Access Compliance Report

Public Rights-of-Way

(Pedestrian Signals)

Intersection ID: N/A	Main Street:	Cross Street: N/A	Location: N/A
ADA ID: 3EC9E81CD592	Signal Type: One Push Button-Non APS	Overall Compliance: No	Severity Score: BTN 1: N/A BTN 2: N/A No BTN: N/A
Codes/Mitigation Info/Possible Solution		Field Measurements/Component Compliance

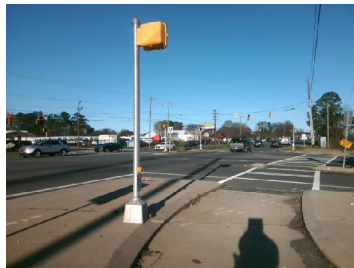
PROW/ADA: TMUTCD 4e.08, R404.2, R404.3, R404.7.3, R404.7.2

Possible Solutions: Replace Signal Push Button With APS Button on New Post. Remove & Relocate Sign.
